ND-2012-0048
September 20, 2012

Subject: **PSEG Early Site Permit Application**
Docket No. 52-043
Response to Request for Additional Information, RAI No. 64, Stability
of Subsurface Materials and Foundations

Response to RAI No. 64

Figure RAI-64-22-1
G/Gmax Comparison of Layer A

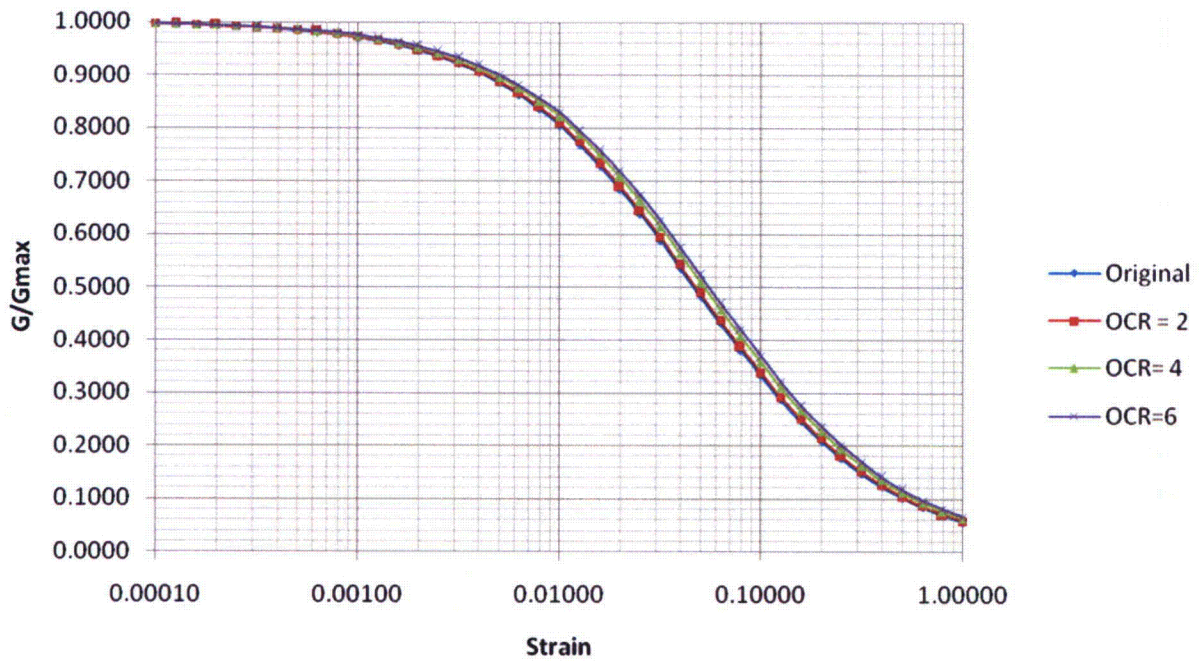
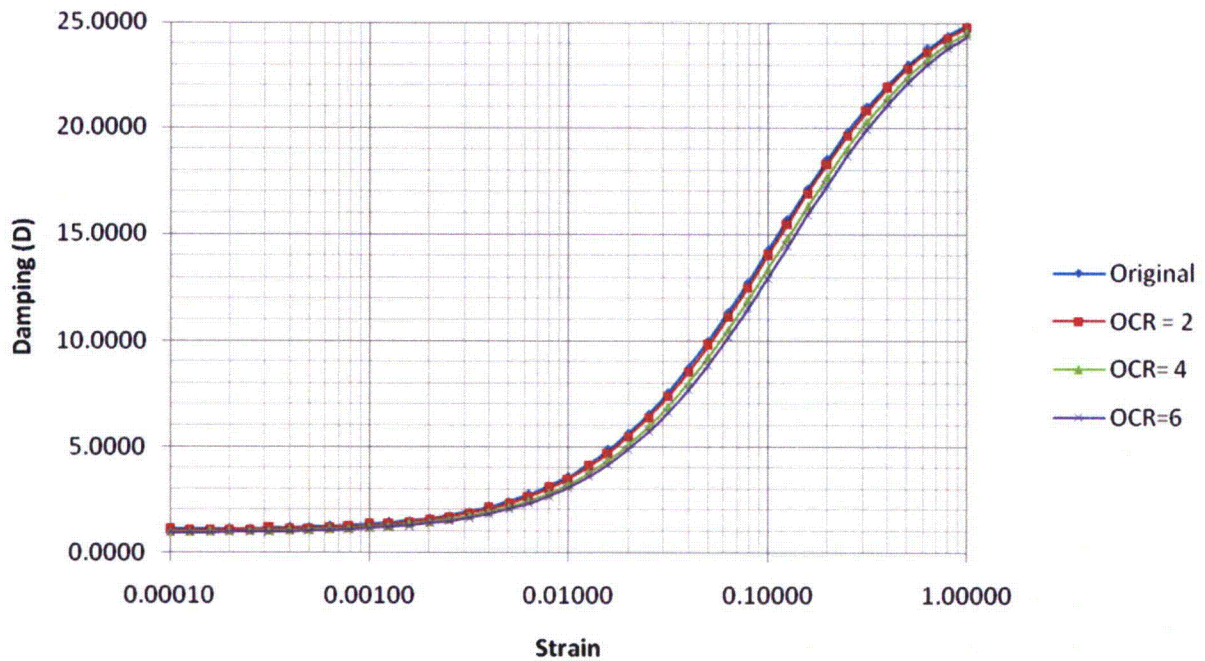
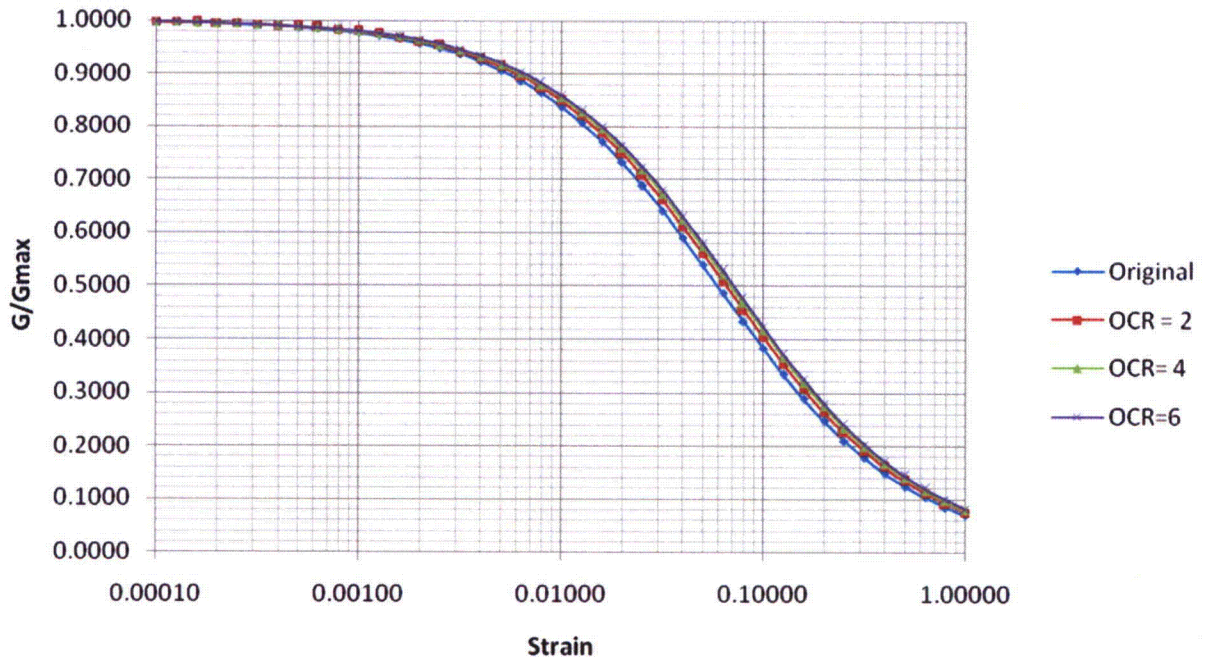
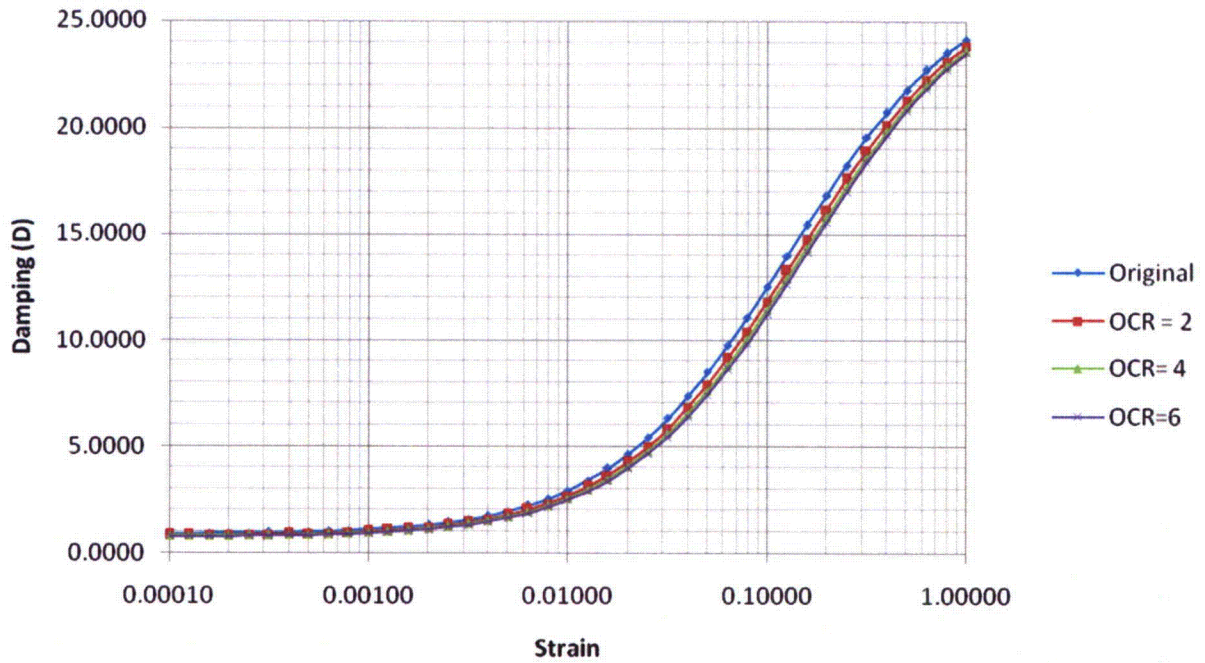
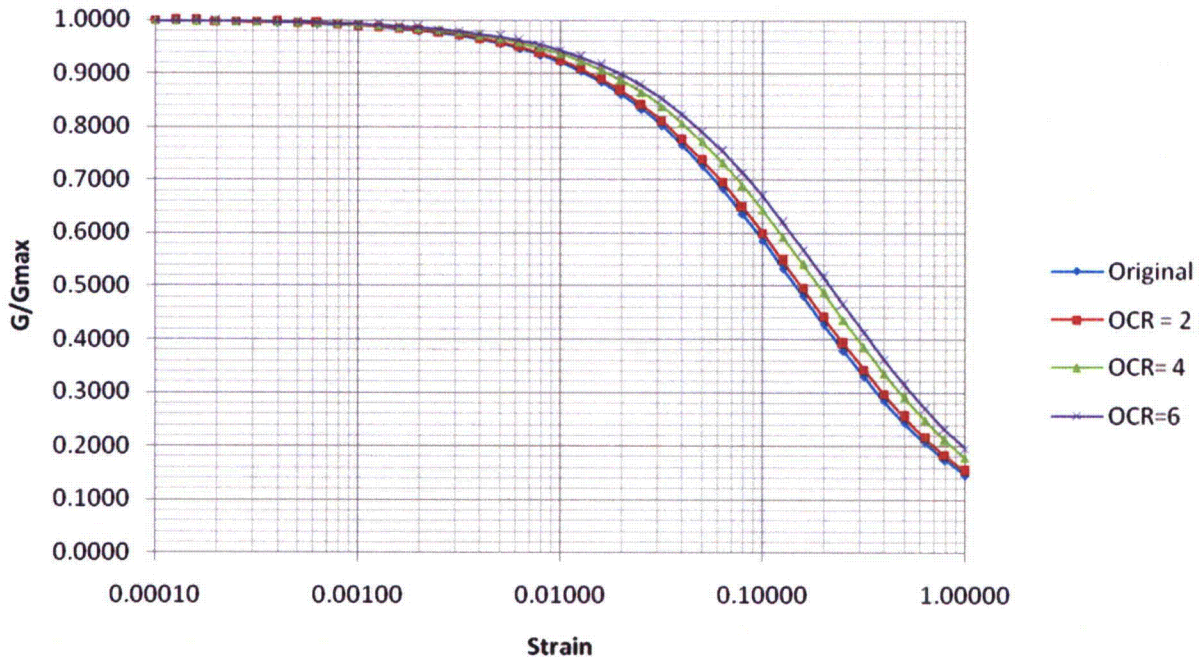
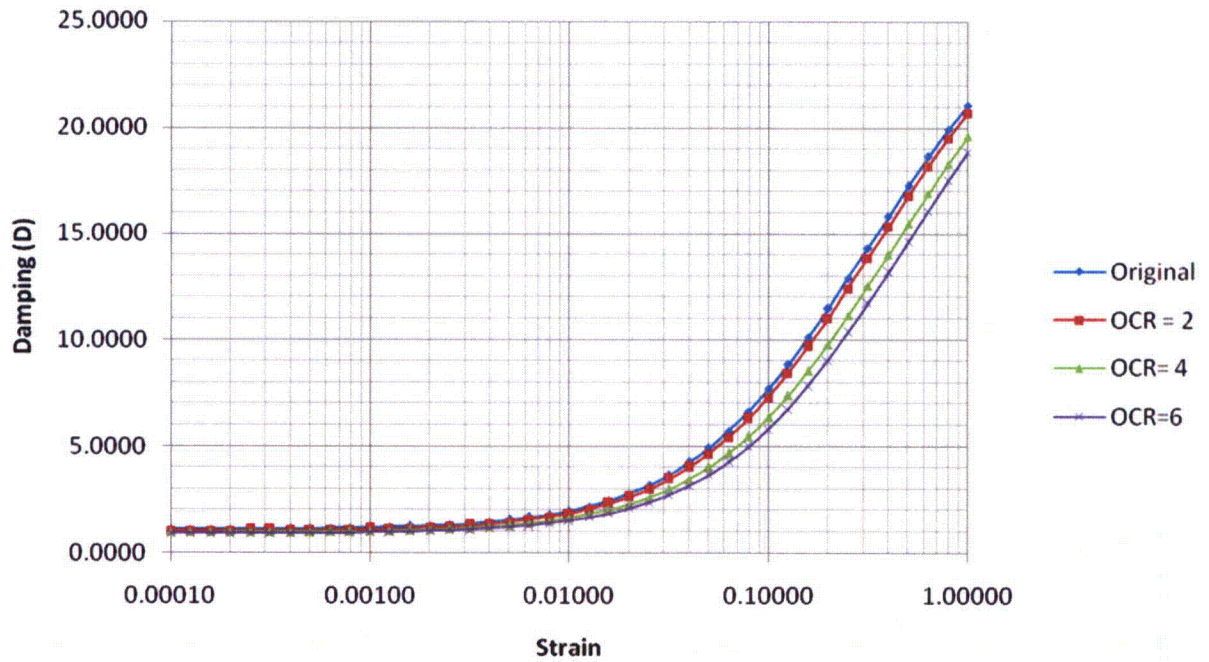
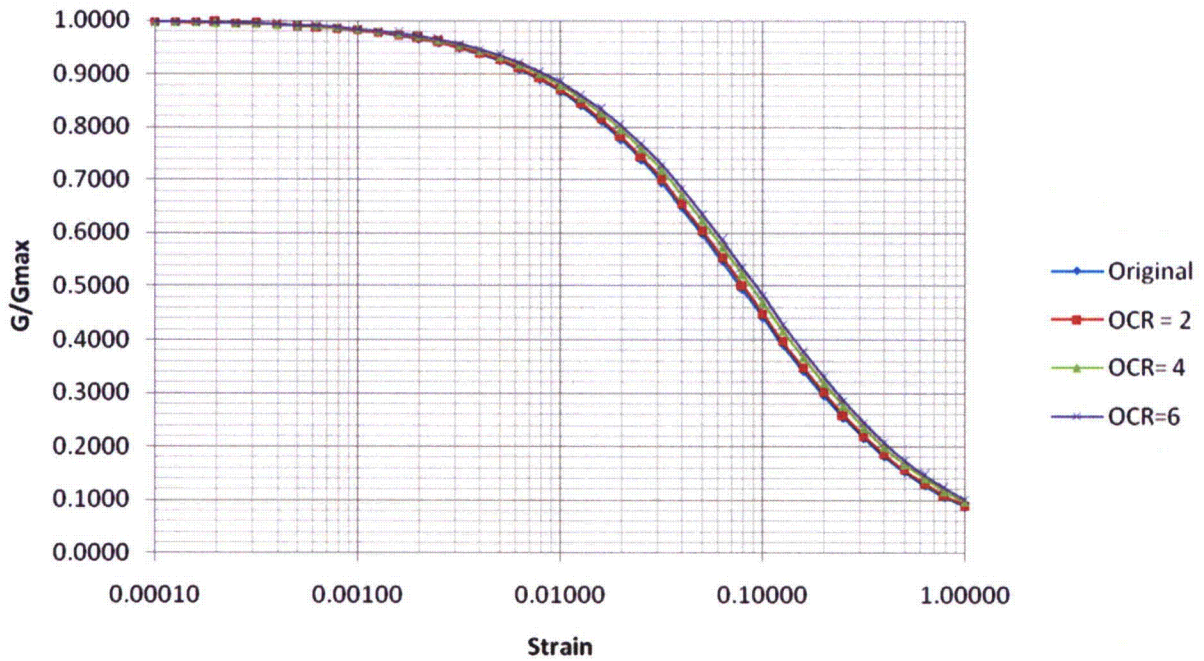
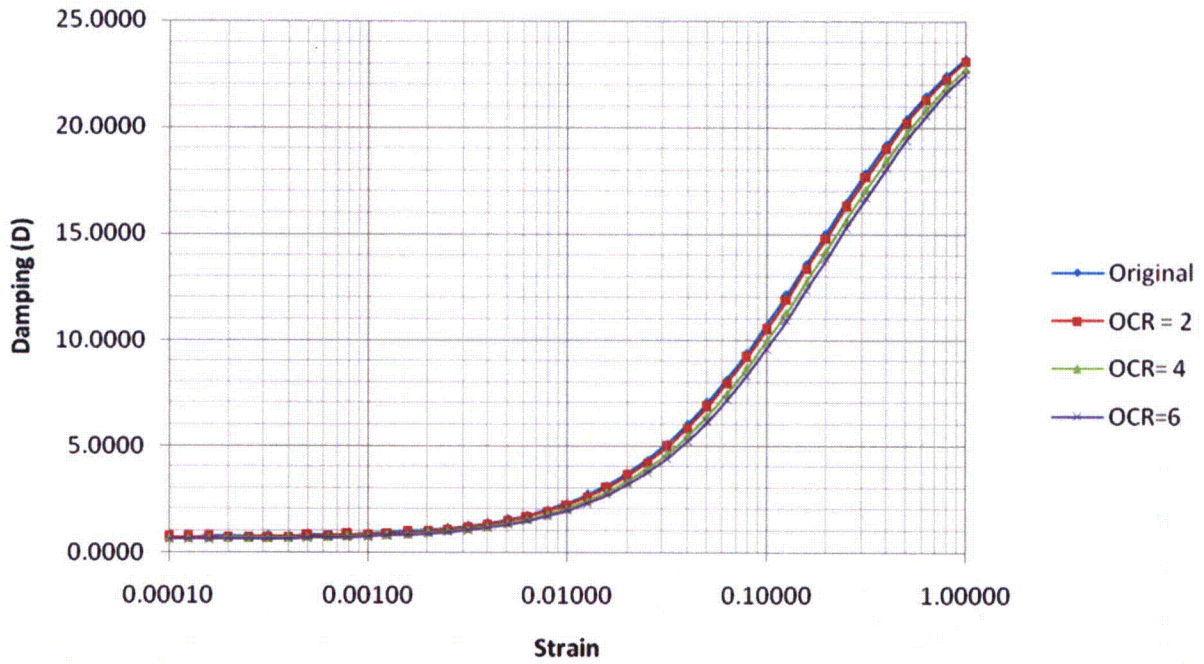
In response to RAI 41, Question 02.05.04-7, you explained how possible variations in the estimated K_o (ratio of vertical to horizontal stress) were accounted for by using multiple test confining pressures for RCTS Testing. Since RCTS tests results were not used to estimate modulus reduction and damping variation with shear strains, and in compliance with 10 CFR100.23(d)(4) and conformance to NUREG-0800, Standard Review Plan, Section 2.5.4, "Stability of Subsurface Materials and Foundations," please explain how variations in the estimated K_o were accounted for when using Darandeli equations. Also, please justify using $K_o=0.5$ shown in calculation package ESP811_PSEG_CALC_2251_ESP_GT_006_REV_2.

The Darendeli equations were run using a single value of K_o for all four layers. K_o is an input which affects the mean effective confining pressure parameter that is an input to the Darendeli equations (Reference RAI-64-22-1). A calculation was performed to explore the effect of different K_o values on the calculated modulus reduction and damping variation with shear strain. A K_o value of 0.5 is commonly assumed for normally consolidated soils. The subsurface soils are overconsolidated as discussed in the response to RAI No. 41, Question 02.05.04-14; however, the degree of overconsolidation is not known. Therefore, three values of overconsolidation ratio (OCR) - 2, 4 and 6 - were used to compute modulus reduction and damping variation with shear strain using the Darendeli equations for comparison with original values.

Figures RAI-64-22-1 through RAI-64-22-8 show the results of the calculation by comparing plots of the G/G_{max} and D variation with shear strain for each of the three OCR cases against the original values from calculation package ESP-811_PSEG_CALC_2251-ESP-GT-006, Rev_2. As can be seen on the figures, there is only a slight increase in the G/G_{max} and D values for the same shear strain values.

Figure RAI-64-23-1-1. Average Field N-values for Vincenttown and Hornerstown Formations vs. Elevation.

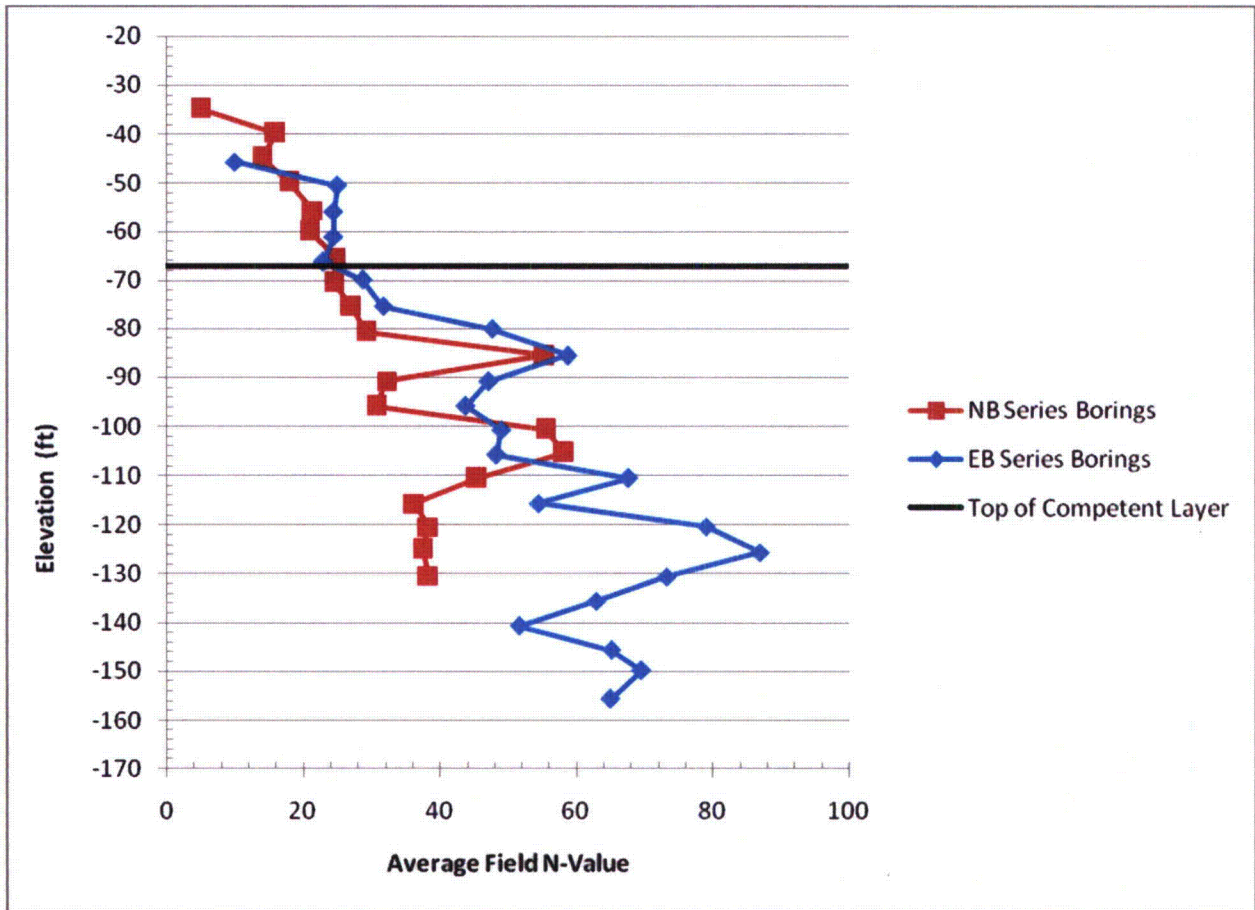
In response to RAI 41, Question 2.5.4-8, you stated that you relied on SPT N-Values, USCS designation and Vs data to demonstrate that soils of the Vincentown and Hornerstown formations were similar laterally across the site and thus, will have similar soil engineering properties. Average field SPT N-Values for the Vincentown and Hornerstown formations were 37 bpf for NB-series borings and 57 bpf for EB-Series borings. In compliance with 10 CFR 100.23(d)(4) and conformance to NUREG-0800, Standard Review Plan, Section 2.5.4, "Stability of Subsurface Materials and Foundations," please explain how these formations were considered to be laterally uniform when considerable variations in average SPT N-Values exist between NB and EB borings. Also, please explain why a design value of 47 bpf was used for the Vincentown and Hornerstown formations in SSAR Table 2.5.4.2.8 and justify how the selected single value statistically reflects the entire layer.

Figure RAI-64-23-1 illustrates the vertical variation of field N-values within the Vincentown and Hornerstown formations, grouped by EB-series and NB-series borings. In SSAR Subsection 2.5.4.5, the top of a competent layer was defined at elevation -67 feet (NAVD 88), near the upper surface of the Vincentown Formation. Figure RAI-64-23-1 shows the position of the competent layer. The plot on Figure RAI-64-23-1 shows loose to medium dense soils in the Vincentown Formation above the competent layer, with average field SPT N-values ranging from approximately 5 to 25 bpf. Materials above the top of the competent layer are to be excavated during construction of the power block. Figure RAI-64-23-1 shows that the average field SPT N-values below the top of the competent layer generally increase with depth in the NB-series and the EB-series borings. The average field SPT N-values recorded in the Vincentown and Hornerstown formations beneath the top of the competent layer have medium dense to very dense relative densities with average field SPT N-values ranging from approximately 25 to 60 bpf for the NB-series borings, and average field SPT N-values ranging from approximately 25 to 85 bpf for the EB-series borings.

The PSEG Site is the area explored by the NB-series borings. Based on the lower average field SPT N-value of 37 bpf determined in the NB-series borings and the planned location of the plant, the design field SPT N-value shown on SSAR Table 2.5.4.2-8 will be revised to reflect only the NB-series borings. The design field SPT N-value shown in SSAR Table 2.5.4.2-8 for the Vincentown and Hornerstown formations will be revised from 47 to 37 bpf. The design corrected SPT N_{60} value will be revised from 70 to 56 bpf and the design corrected SPT $(N_1)_{60}$ value will be revised from 35 to 32 bpf.

Figure RAI-64-26-1. Preconsolidation Pressure vs. Liquidity Index

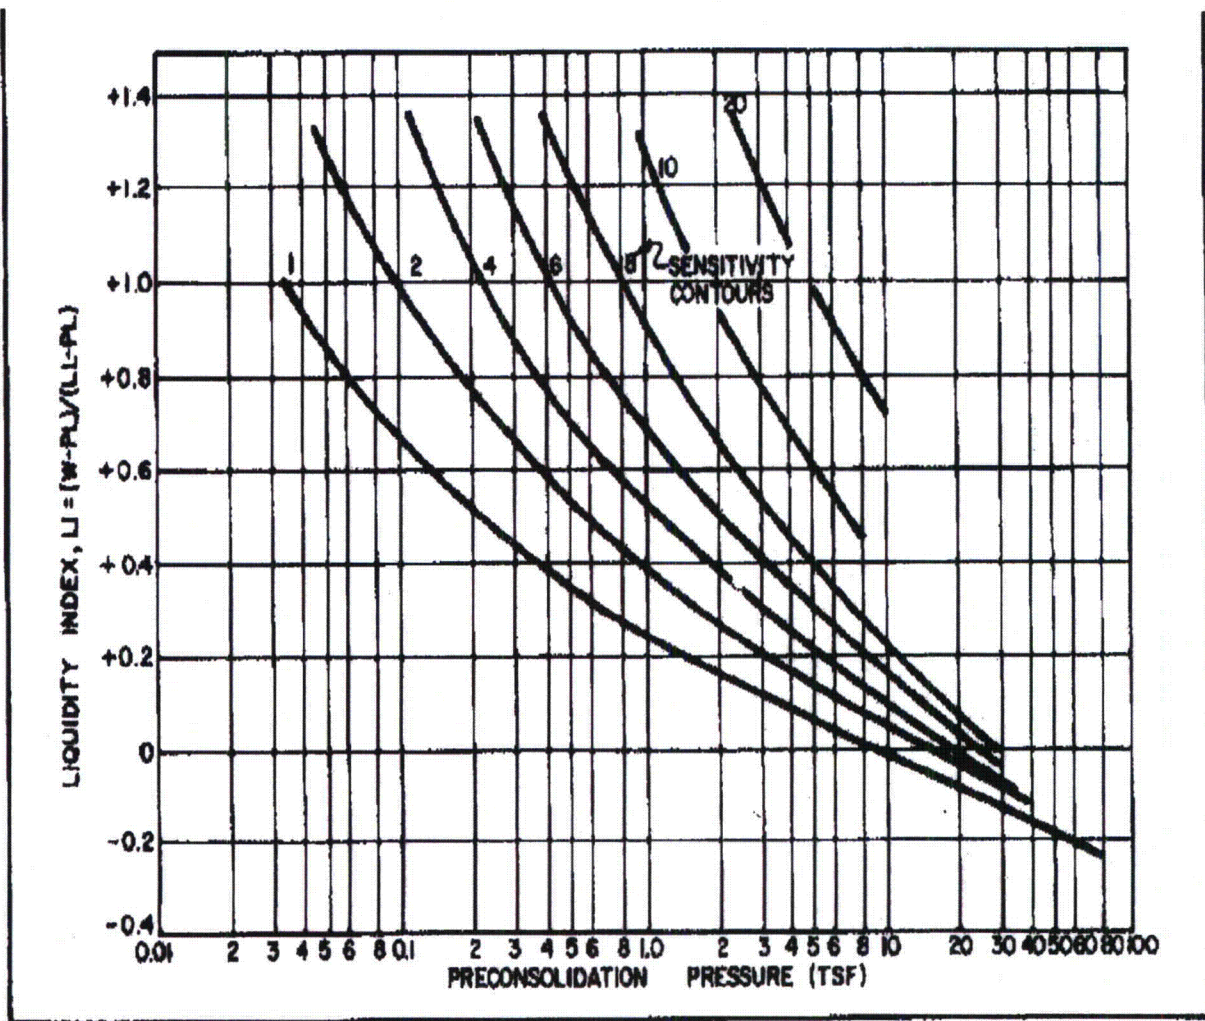
- 1. Please indicate if laboratory tests on site subsurface soils will be performed to assess consolidation properties during the COLA phase.*
- 2. Explain why the information from ESP subsurface investigations was not used to assess consolidation properties (e.g. Atterberg limits) to support your conclusions.*

2. Figure RAI-64-26-1 shows a chart from the United Facilities Criteria, Soil Mechanics (UFC-3-220-10N) (Reference RAI-64-26-1); that relates the Liquidity Index (a parameter derived from Atterberg limits tests) and preconsolidation pressure for varying degrees of sensitivity. The preconsolidation pressure is the highest vertical pressure to which a soil layer has been subjected in the past. Considering that the geologic age of the Englishtown, Woodbury, and Merchantville formations (those formations with clayey zones), is more than 72 million years, it would be expected that the preconsolidation pressures would at least be equal to the present overburden pressures. The present effective overburden pressures include the weight of materials placed to form Artificial Island in the area of the PSEG Site between approximately 1900 and 1990. Due to the elapsed time since Artificial Island was formed, excess pore pressures from its formation would be fully dissipated.

Table RAI-64-26-1 summarizes the Liquidity Indices from the seven Atterberg limits tests that were performed on samples from the Englishtown, Woodbury, and Merchantville formations as part of the ESPA exploration, the estimated existing overburden effective pressures based on site conditions and values of preconsolidation pressures derived from Figure RAI-64-26-1. As can be seen, the existing effective overburden pressures are inconsistent (but typically greater) with respect to the preconsolidation pressures estimated from Figure RAI-64-26-1. These results were interpreted during the ESP work as indicating use of Atterberg limits tests to further assess consolidation properties was not likely to be reliable for the soils in the Englishtown, Woodbury, and Merchantville formations.
